Clarification of officer remarks re GME Motion 1.. Footpath Safety.

The Agenda for the City of Melville OMC 15 March 2022 contains Officer remarks pertaining to safe location of footpaths within road reserves. Some clarification of those remarks is necessary, as below:

Figure 6 Example of Design Showing Path Priority

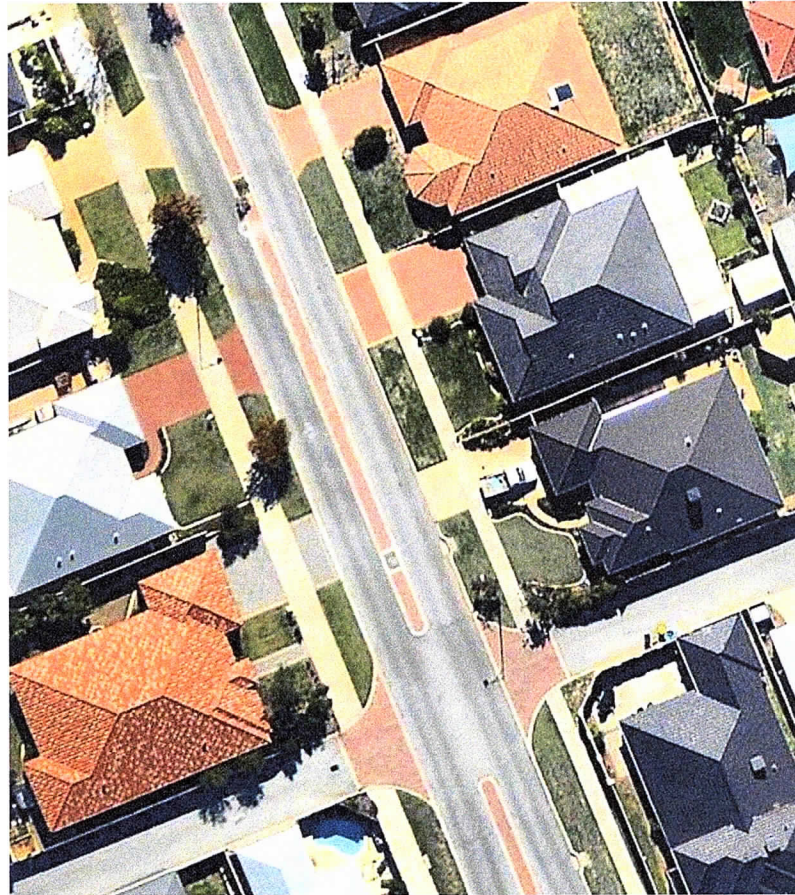
3. The minimum 500mm offset of the path from the kerb mentioned by WALGA, and Fig 7 on page 10 of the WALGA guidelines shows the path discontinuing in the kerb ramp offset zone, and the path continuing with a fixed width unaffected by kerb ramps. WALGA goes on to cite Austroads Part 6A advice that paths should be located at least 500mm, and preferably 1m from any significant obstruction or hazard, including the roadway, to provide sufficient separation and safety. To fill the offset area with concrete identical to the footpath introduces a hazard for pedestrians. That is why “soft landscaping/vegetation” is recommended for the offset zone. Austroads Guidelines recommends, on page 26, “It is also important that the edges of paths do not have a drop-off that may cause a pedestrian to slip or trip, or cause a wheelchair to overturn, such as along the back of the kerb. This consideration is critical where minimum path widths are used.” Again, a safe system approach. A vegetated zone adjacent to the kerb allows footpath users an area of run-off from the path which provides a buffer and soft fall area away from the carriageway.

An example of a good design is shown in the **Figure 6** which illustrates consistent crossover design with priority pedestrian access.

Figure 2.1: Examples of pedestrian path zones

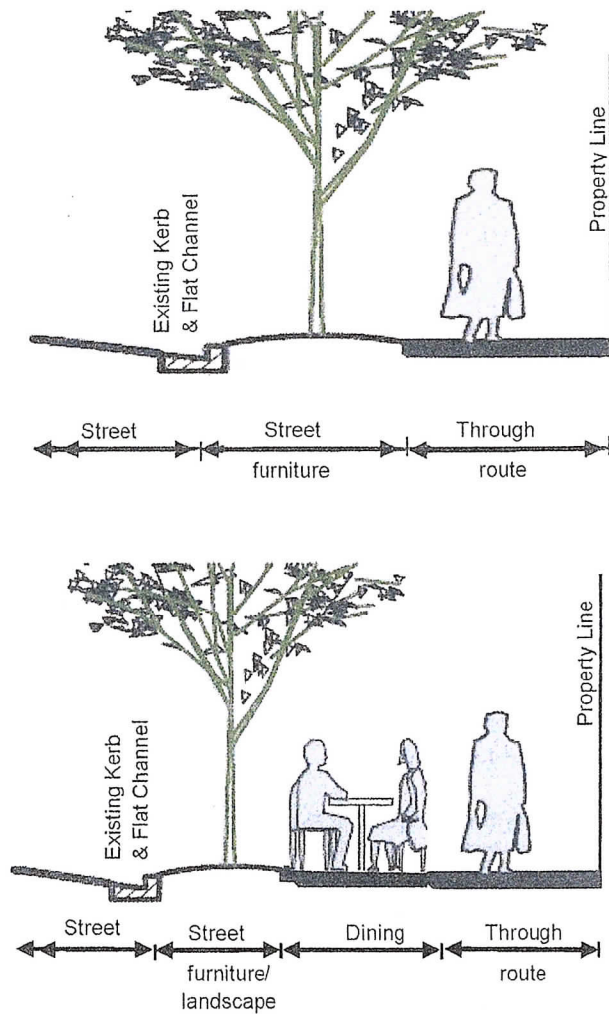
footpath. (I note that the bus shelter is a little close to the path, but this is easily fixed.) This is achieved by having the street trees in the kerbside furniture zone as shown in the Austroads Guidelines.

Figure 5.8: Location of path in road reserve

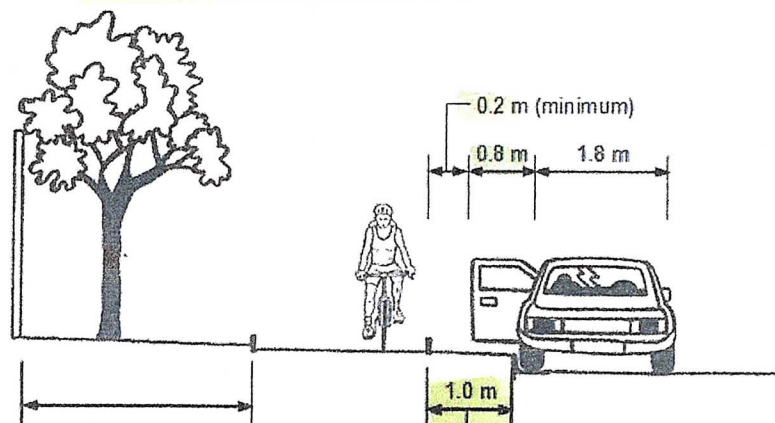
1. A nominal 1.8m wide footpath at the kerb has a clear and effective width of only 1.2m. Kerb ramps reduce the width by 600mm, or 30 percent of the width, for 33 percent to 45 percent of the path length, depending on the property frontage distance, and the crossover width. The repetitive placement of low visibility kerb ramps within the footpath, where keeping left is a common courtesy, presents a danger to pedestrians, and is a disincentive to walk. Every time a pedestrian walking kerbside of the path reaches a kerb ramp, they have to move to the right to avoid the ramp, and are likely to be hit from behind by a bike or eScooter that was not anticipating such a movement across the path by the pedestrian. Austroads Part 6A. recognises and advises against such practice. Austroads advice is that having the edge of the path 1m behind the kerb “provides essential clearance to parked cars. Path avoids kerb returns at driveways.” ie. A safe system approach.

Provides essential clearance to parked cars. Path avoids kerb returns at driveways
